PALAU SUNSET HARBOR

"FIRST SUBMITTAL", JULY 07,2020

- (1) FAÇADE TILE CHANGE TO A SMOOTH DESIGNER CEMENT PLASTER (STUCCO)**
- (2) INSTALL ARCHITECTURAL GUTTERS OVER RETAIL**

PALAU SUNSET HARBOR - SCOPE OF WORK

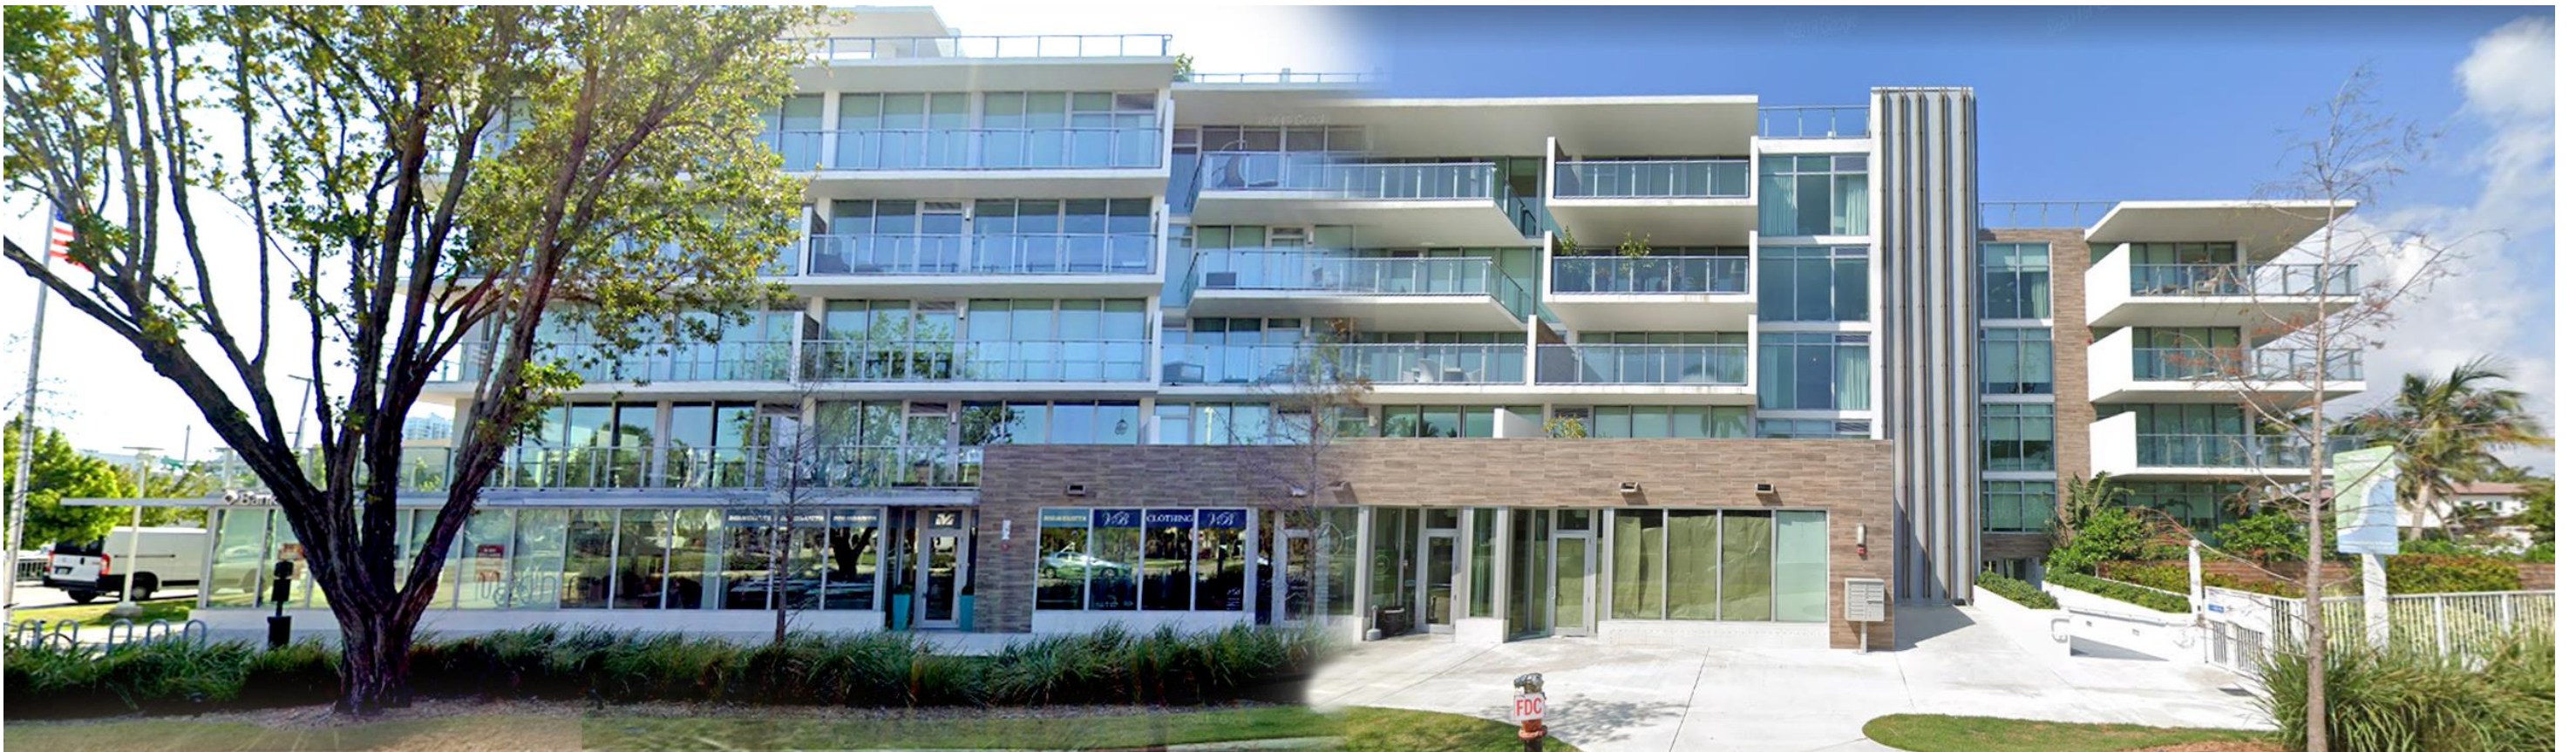
(1) FAÇADE TILE CHANGE TO A SMOOTH DESIGNER CEMENT PLASTER (STUCCO): We have been advised by our Engineer to replace all existing façade tiles due to safety and performance issue concerns. Where the original contractor installed the tiles with mortar over the cement plaster, the mortar has a surface showing many voids that do not meet industry standard requirements; as a result, the tiles have been buckling from the walls and delaminating from the substrate. This issue is a safety matter that the Association has been addressing on an "as needed" basis with emergency repairs as the buckling tiles are located over areas where pedestrians and automobiles pass. Our engineers confirmed that this situation would be ongoing due to the methods used to mount the tile and weather exposure. Due to the seriousness of this condition as a safety issue and the fact that we would like a permanent solution to avoid significant ongoing future expenses and injuries, we are proposing a more efficient remedy. Palau would like to replace the facade tiles with a smooth, concrete appearance, designer cement plaster with a fully integrated color as our first option. This solution will maintain the modern look and feel of the building, which is in line with similar classic treatments used throughout Miami Beach. Alternately we would replace tile along selective visible areas with a new tile

(2) INSTALL ARCHITECTURAL GUTTERS OVER RETAIL: We would like to install an architectural gutter over the retail units on the east side of Palau. Currently, five scuppers pour out water during rainfall, and every time a unit owner washes their balcony. The gutters sit above the retail units storefront, thus the water pours out on the shops' patrons and employees. We want to install painted aluminum gutters, which will be powder coated in a color that will match the adjacent painted stucco closely. There are two existing storm drains that will drain the water.

SOUTH ELEVATION – 20TH STREET

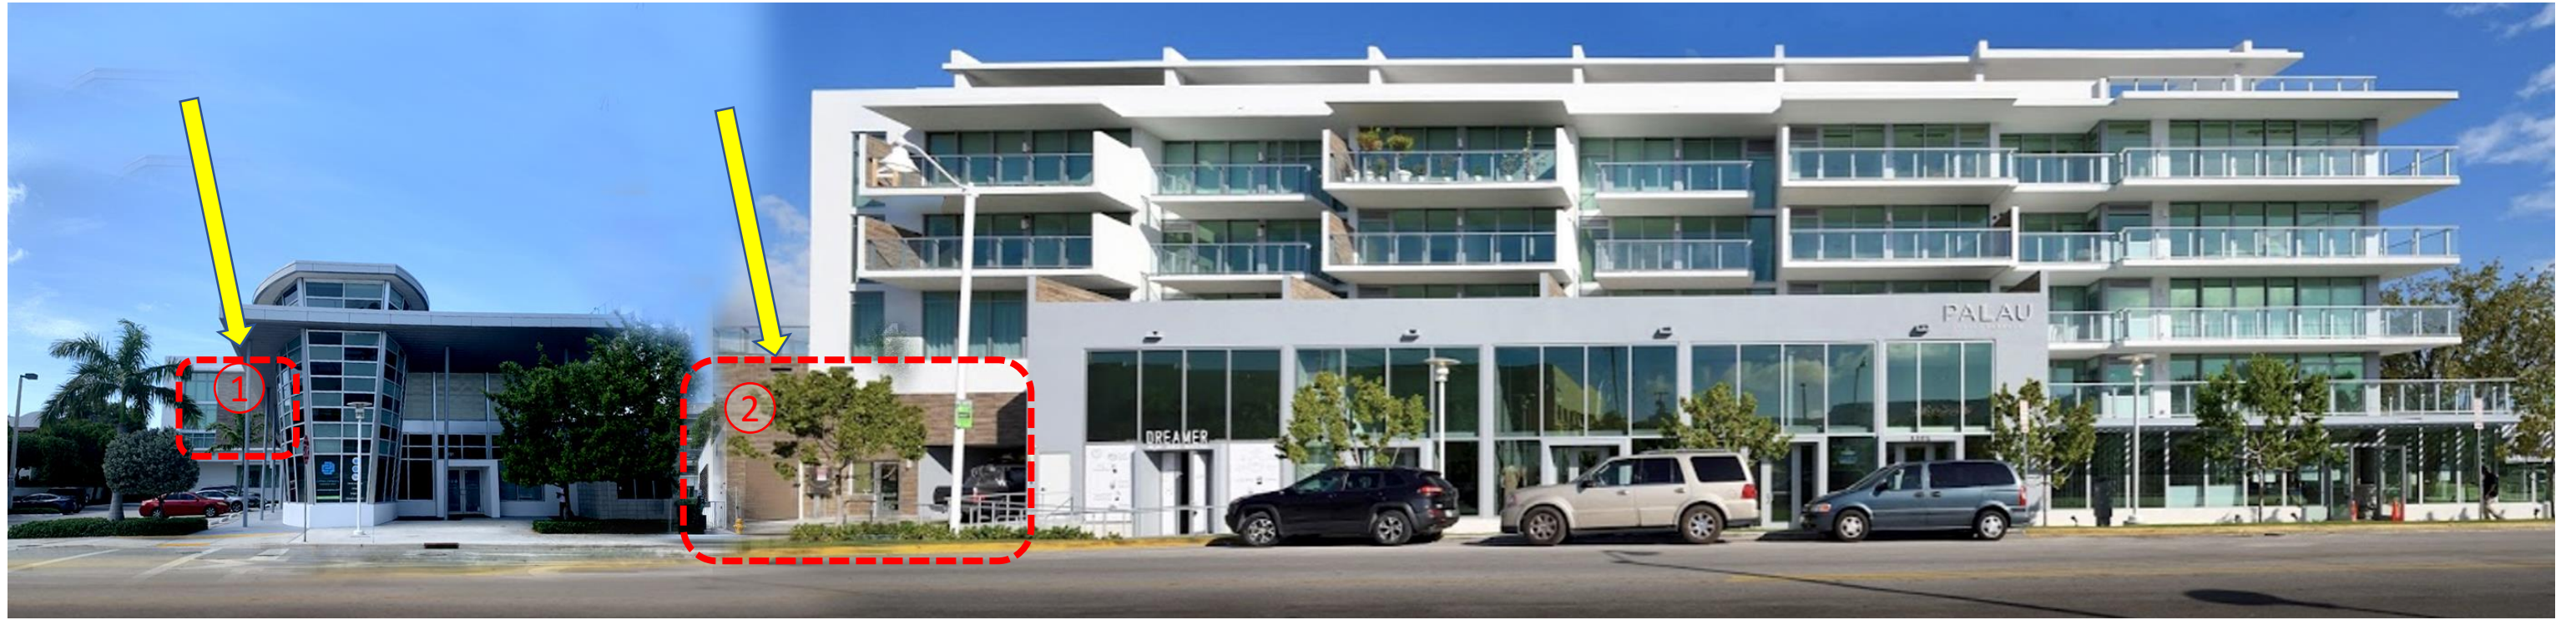
Proposed Elevation

SOUTH ELEVATION 20th St - 14 550 SF
 TILE AREA – (1) 648.98 + (2) 586.55 = 1235.33 SF
 COVERED TILE - 8.5 %

SOUTH ELEVATION

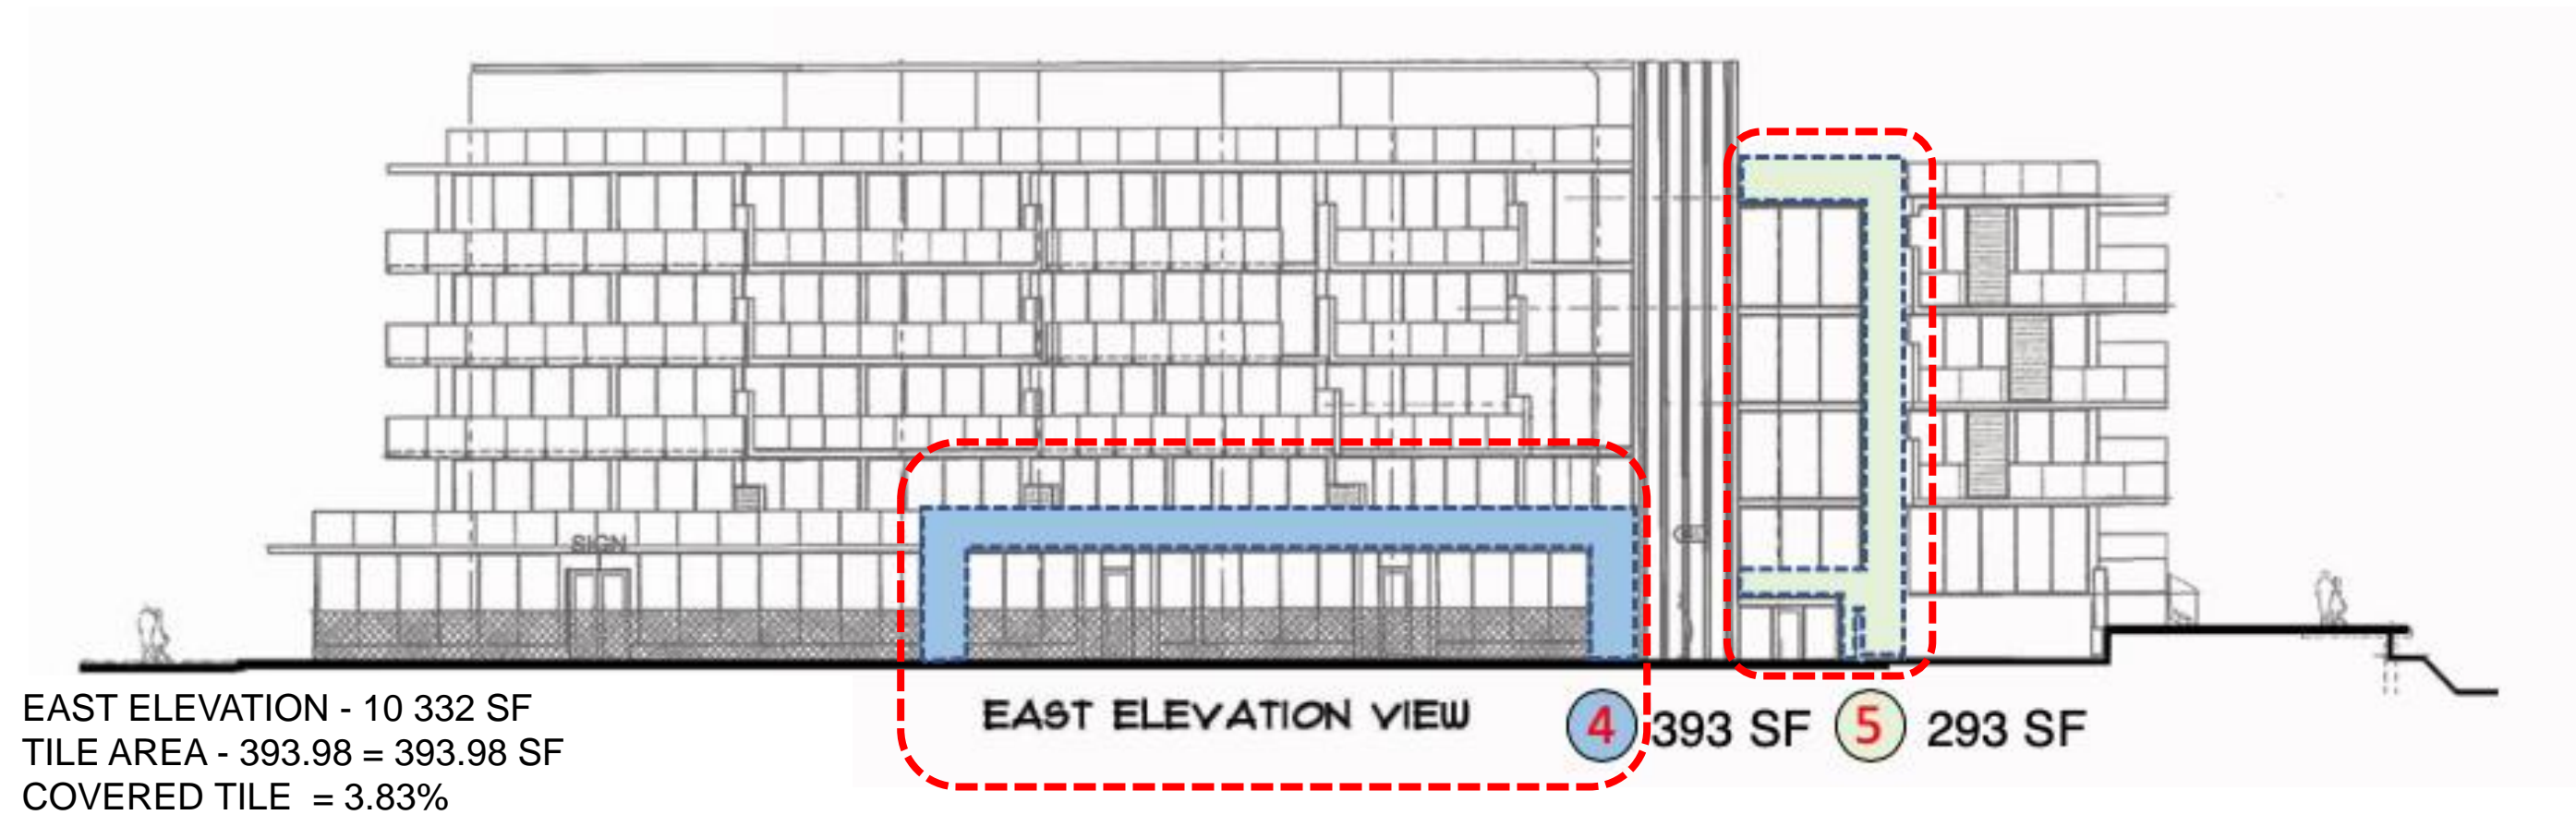
Option A
Proposed Material –Stucco as per Mock-up #4

Option B
Proposed Material –Tile Elevation 1

SOUTH ELEVATION - 14 550 SF
TILE AREA (2) 586.55
COVERED TILE - 4.03 %

EAST ELEVATION- SUNSET DRIVE

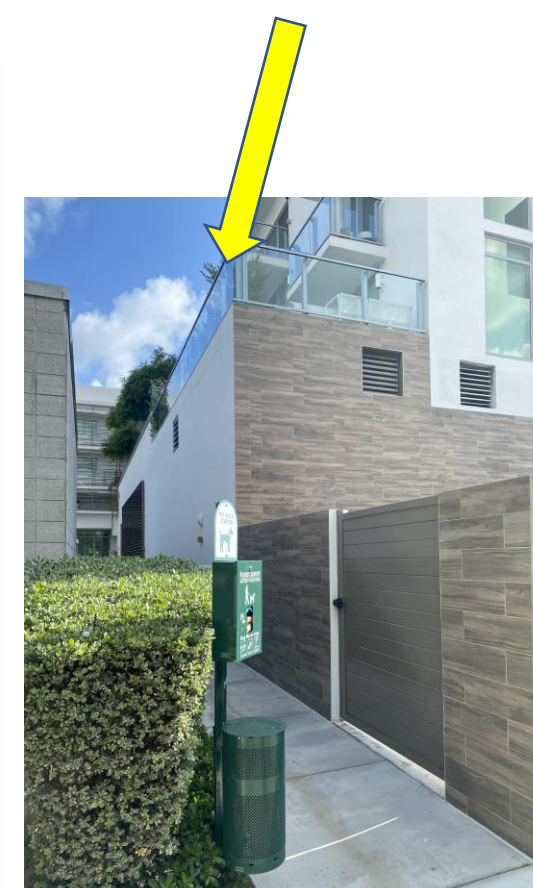
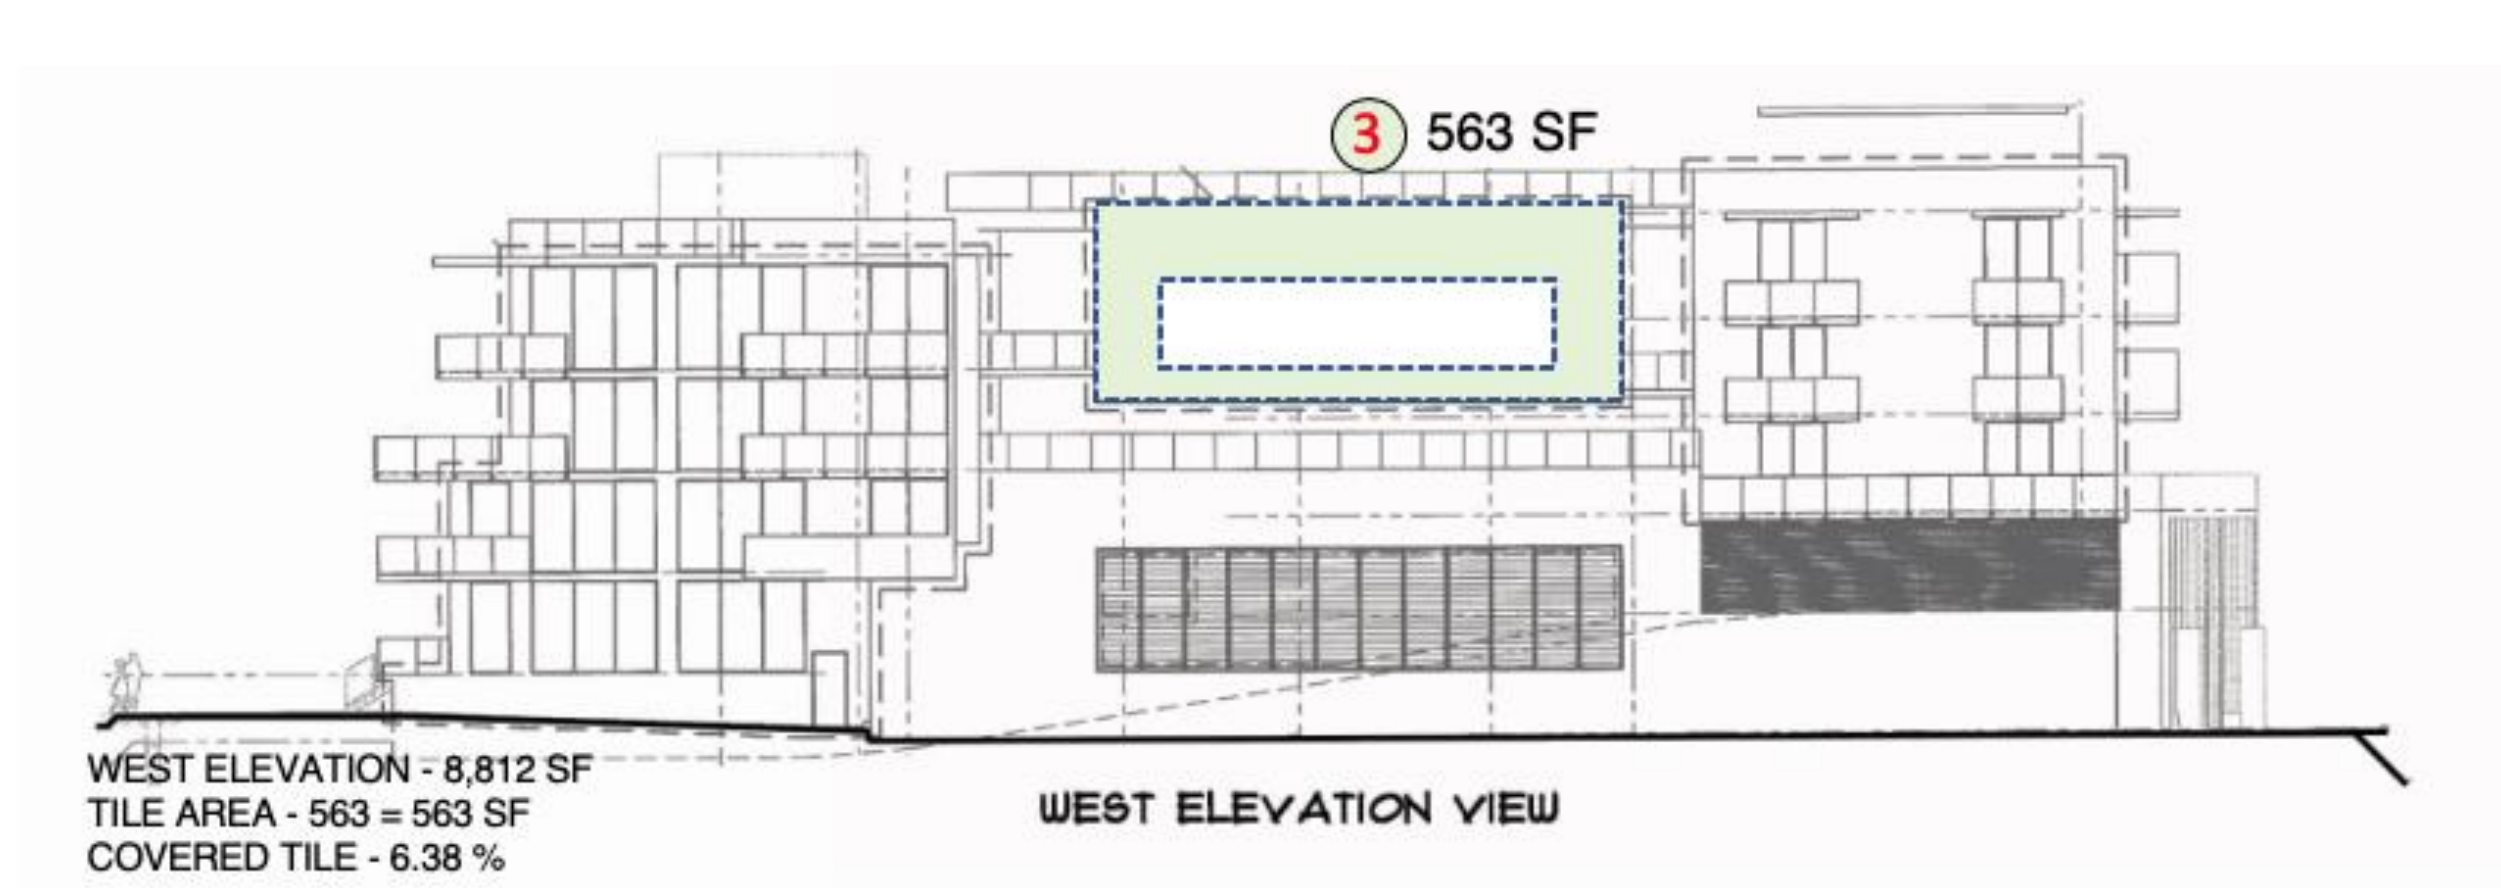
Option A
Proposed Material –Stucco as per Mock-up #4 & White Stucco for Area 5

EAST ELEVATION - 10 332 SF
TILE AREA -(4) 393.98 = 393.98 SF
STUCCO AREA- (5) 293.18 SF
COVERED TILE – 3.83 %
